Recall Bulletin

PRODUCT SAFETY RECALL

SUBJECT: Shift Lever Indicator May Not Display Correct Gear

MODELS: 2008-2010 Chevrolet Malibu
2008-2010 Pontiac G6
2007-2010 Saturn AURA
Equipped with 4-Speed Automatic Transmission (ME7/MN5)

2269489

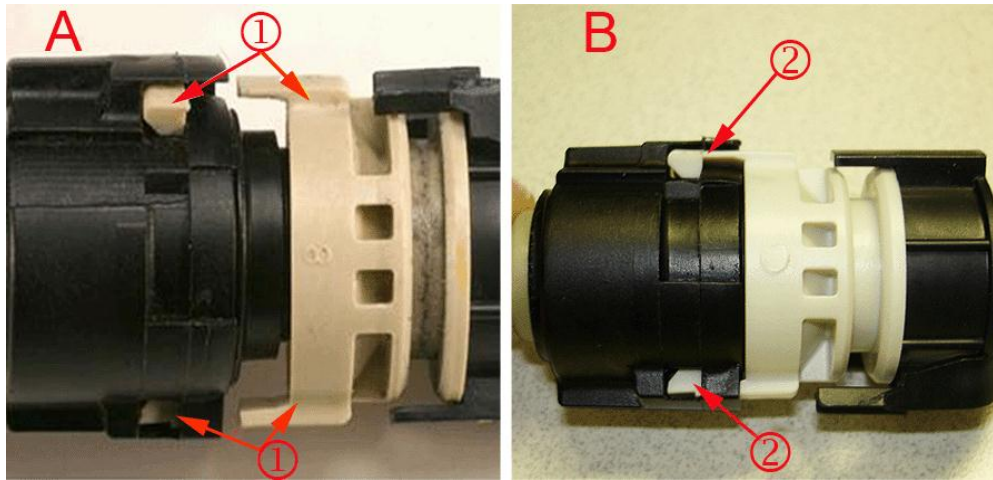
- (1) Shift Cable Locking Tabs
- (2) Shift Cable Adjuster Locking Clip

1. Open the hood and locate the transmission shift cable.

2269486

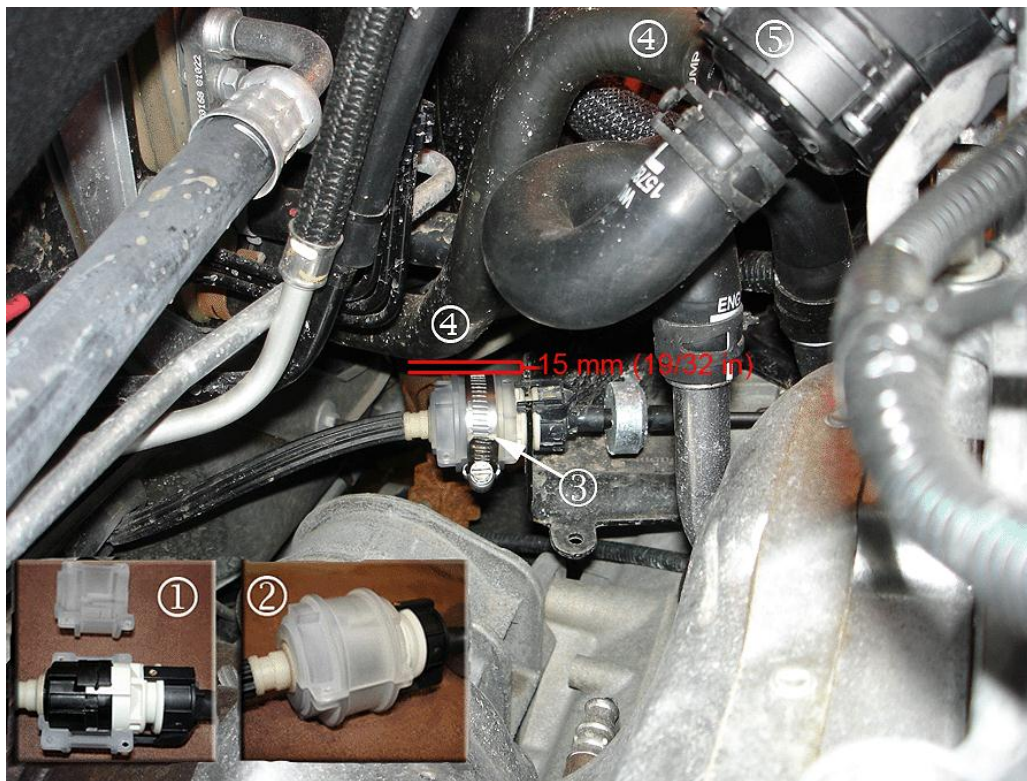
2. Determine if the transmission shift cable locking tabs are fractured and separated.

- If the transmission shift cable locking tabs (1) are fractured and separated (A), remove the transmission shift cable and replace it with a new one. Refer to *Floor Shift Control Cable Replacement or Range Selector Lever Cable Replacement* in SI. **Also install a transmission shift cable kit with the new shift cable.**
- If the transmission shift cable locking tabs (2) are NOT fractured and separated (B), install the transmission shift cable kit. Proceed to Step 3.
